3/4.9.12 FUEL STORAGE - SPENT FUEL STORAGE POOL

### 3/4.9.13 SPENT FUEL ASSEMBLY STORAGE

The primary purpose of this submittal is to demonstrate sufficient analytical justification for modifying technical specifications and FSAR sections currently applicable to new and irradiated fuel storage at the McGuire Nuclear Station (MNS). Areas proposed for modification are the limitations and restrictions associated with 1) storage of un-irradiated fuel in auxiliary building new fuel storage vaults, 2) storage of irradiated and un-irradiated fuel in the region 1 areas of both spent fuel pools, and 3) storage of irradiated and un-irradiated fuel in the region 2 areas of both spent fuel pools.

Table 3.9-1

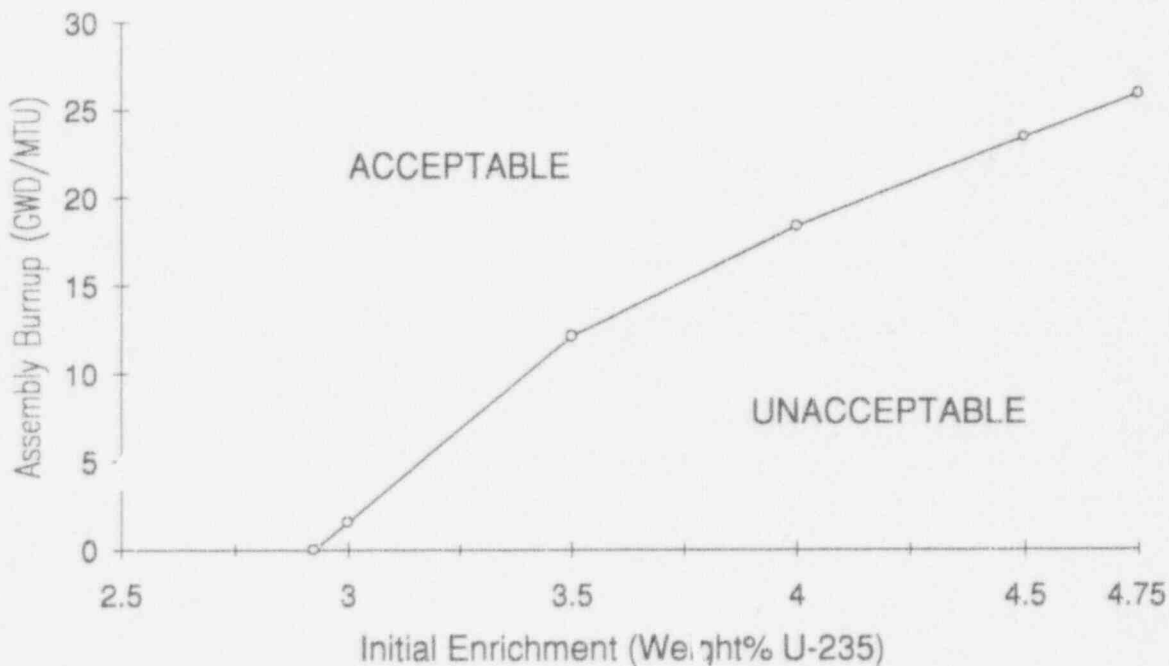
*add to  
3/4.9.13*

<u>Initial Enrichment Weight% U-235</u>	<u>Assembly Burnup (GWD/MTU)</u>
4.19 (or less)	0
4.20	0.04
4.50	1.92
4.75	3.40

Table 3.9-2

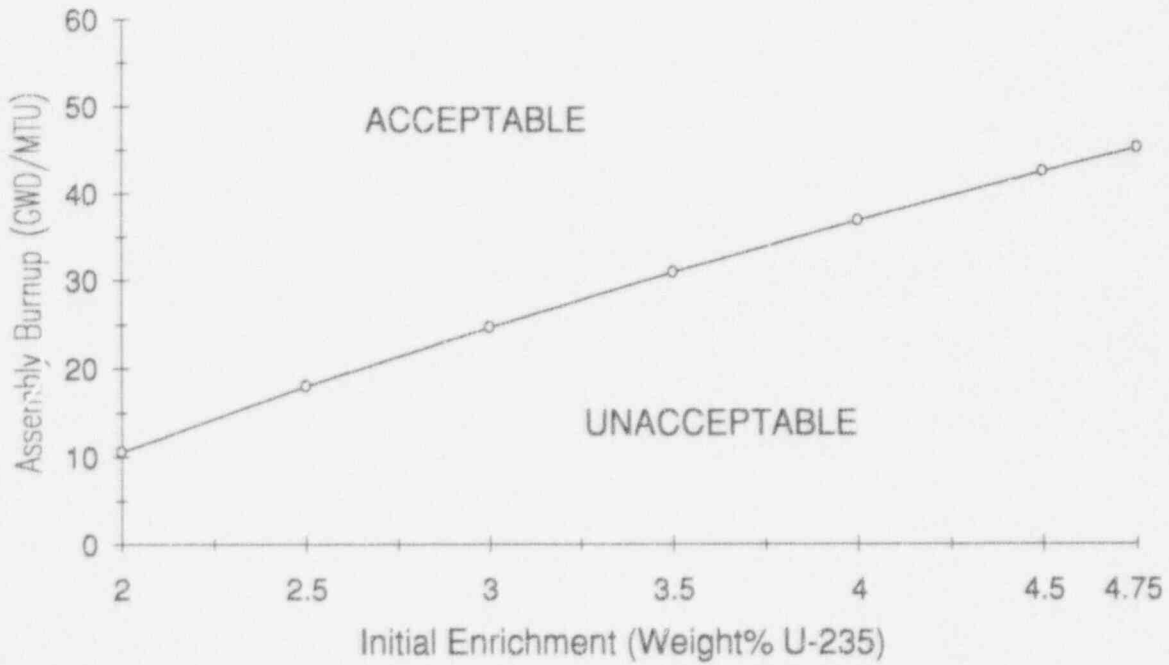
*add  
new  
3/4.9.13*

<u>Initial Enrichment Weight% U-235</u>	<u>Assembly Burnup (GWD/MTU)</u>
2.92 (or less)	0
3.00	1.57
3.50	13.30
4.00	18.32
4.50	23.36
4.75	25.84

Table 3.9-3

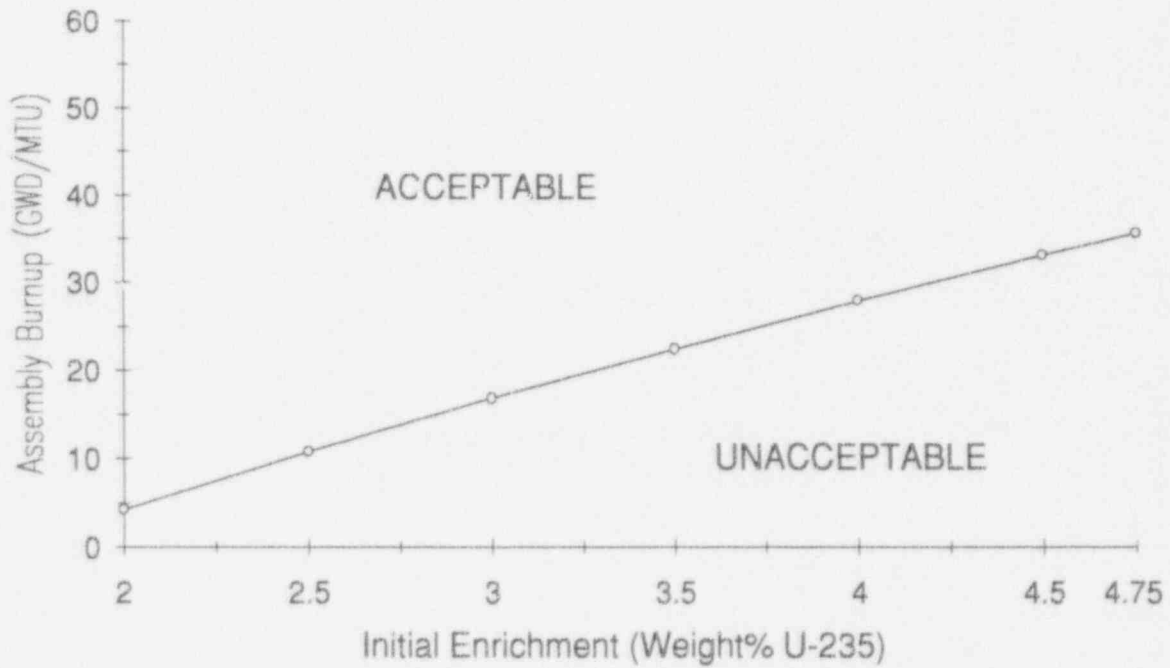
*add to  
3/4.9.13*

<u>Initial Enrichment Weight% U-235</u>	<u>Assembly Burnup (GWD/MTU)</u>
2.00 (or less)	10.54
2.50	17.96
3.00	24.64
3.50	30.86
4.00	36.75
4.50	42.38
4.75	45.10

Table 3.9-4

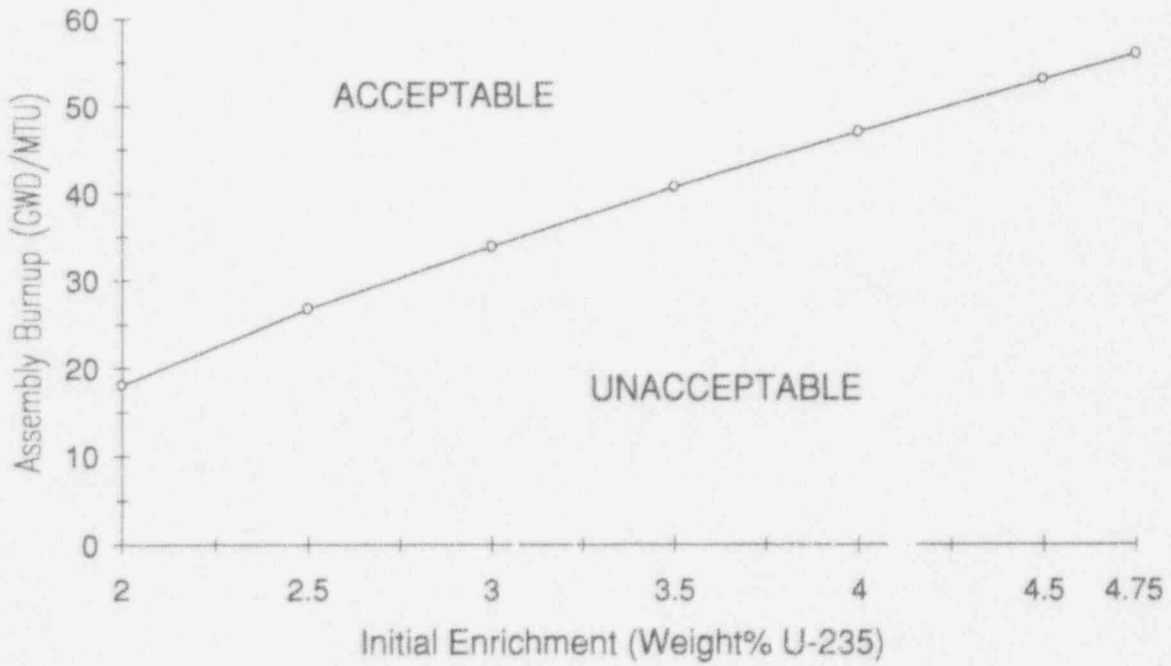
*add to  
3/4.9.13*

<u>Initial Enrichment Weight% U-235</u>	<u>Assembly Burnup (GWD/MTU)</u>
2.00 (or less)	4.22
2.50	10.75
3.00	16.80
3.50	22.41
4.00	27.92
4.50	33.14
4.75	35.65

Figure 3.9-1  
Required 3 out of 4 Loading Pattern  
for Restricted Region 1 Storage

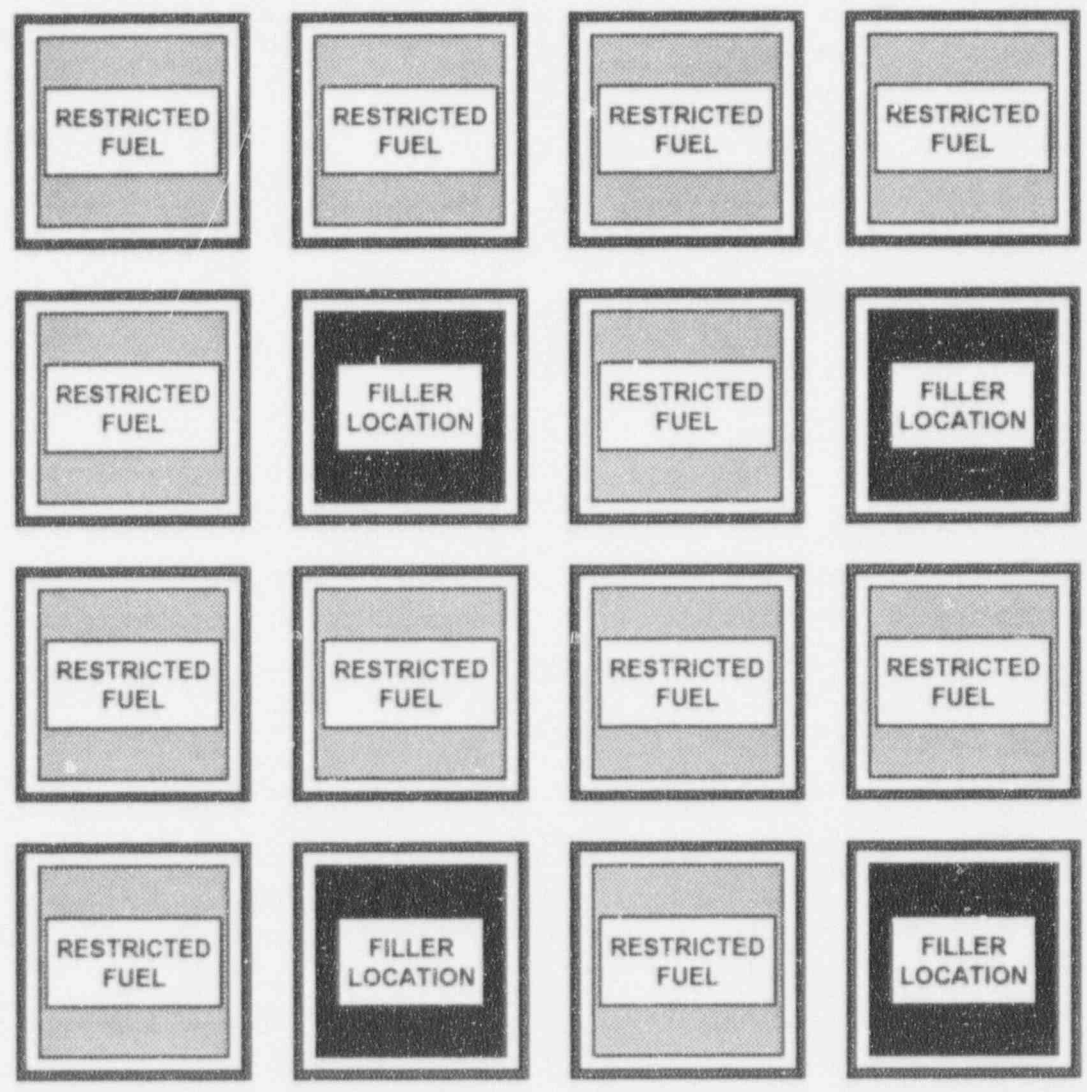
add to  
3/4.9.13

- Restricted Fuel:** Fuel which does not meet the minimum burnup requirements of Table 3.9-1. (Fuel which does meet the requirements of Table 3.9-1 may be placed in restricted fuel locations as needed)
- Filler Location:** Either fuel which meets the minimum burnup requirements of Table 3.9-2, or an empty cell.
- Boundary Condition:** Any row bounded by a Region 1 Unrestricted Storage Area shall contain a combination of restricted fuel assemblies and filler locations arranged such that no restricted fuel assemblies are adjacent to each other.  
Example: In the figure above, row 1 or column 1 can not be adjacent to a Region 1 Unrestricted Storage Area, but row 4 or column 4 can be.

Figure 3.9-2  
Required 2 out of 4 Loading Pattern  
for Restricted Region 2 Storage

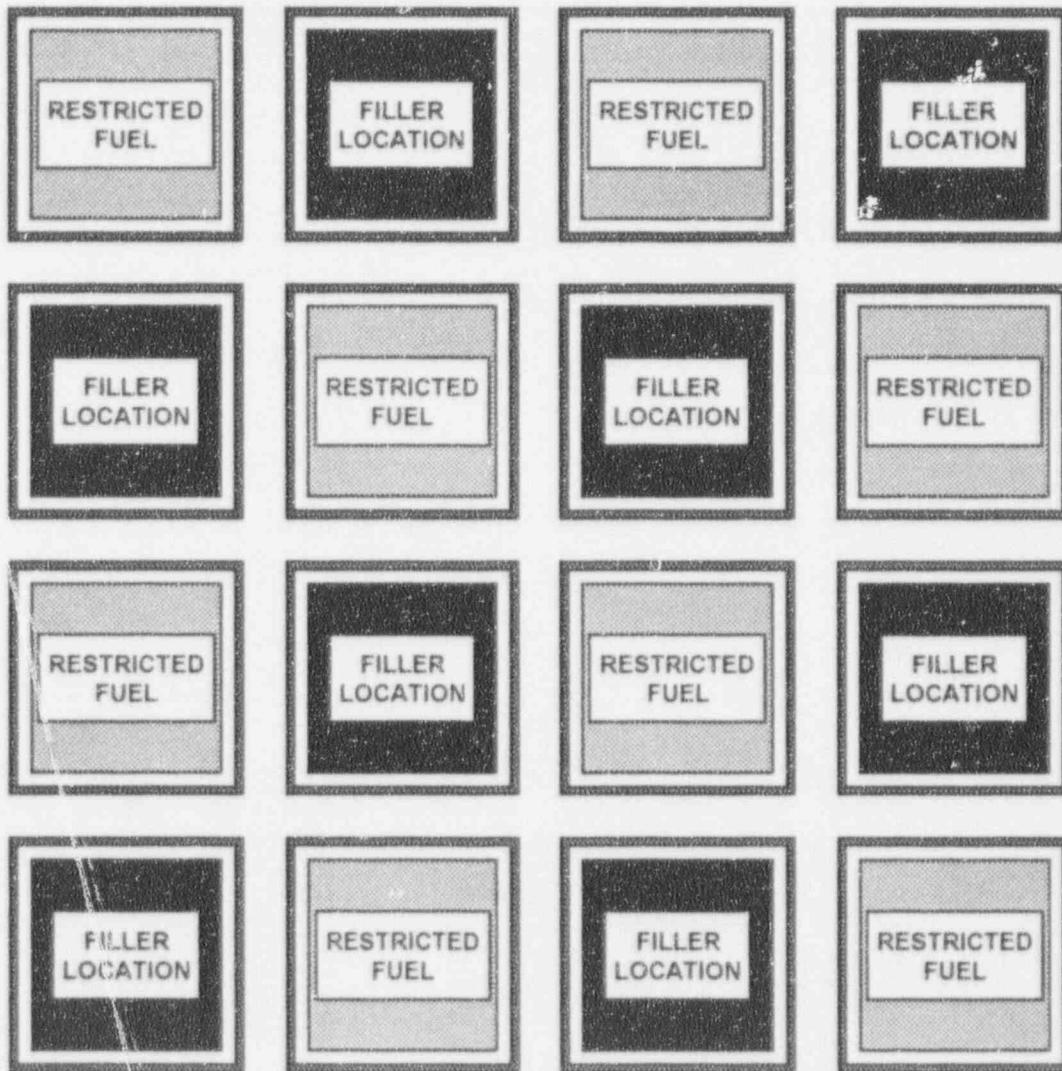
*add to  
3/4.9.13*

Restricted Fuel: Fuel which meets the minimum burnup requirements of Table 3.9-4.

Filler Location: Either fuel which meets the minimum burnup requirements of Table 3.9-5, or an empty cell.

Boundary Condition: No restrictions on boundary assemblies.

Figure 3.9-3

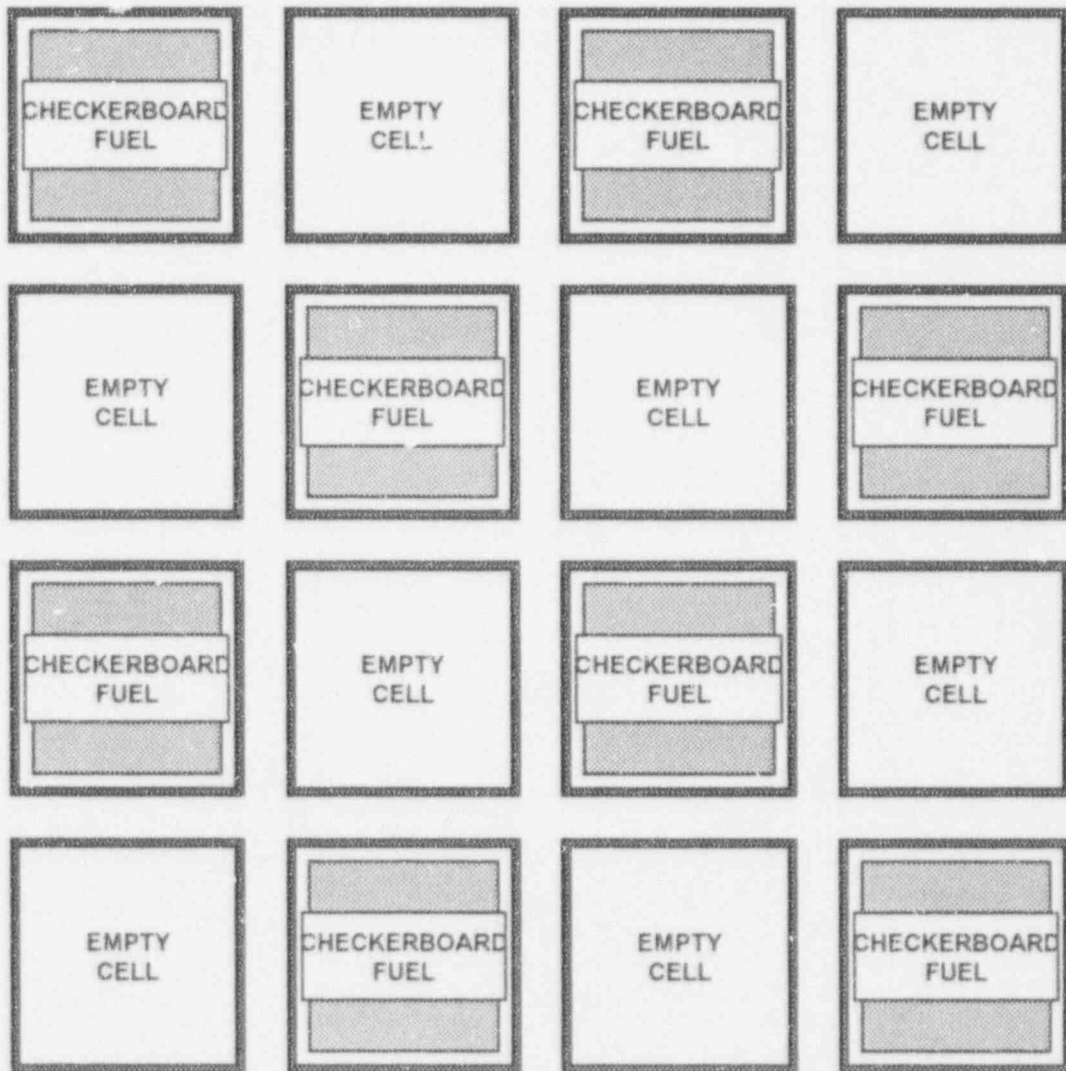
add to  
3/4.9.L3

Checkerboard Fuel: Fuel which does not meet the minimum burnup requirements of Table 3.9-4. (Fuel which does meet the requirements of Table 3.9-4 may be placed in checkerboard fuel locations as needed)

Boundary Condition: At least two opposite sides shall be bounded by either an empty row of cells, or a spent fuel pool wall.
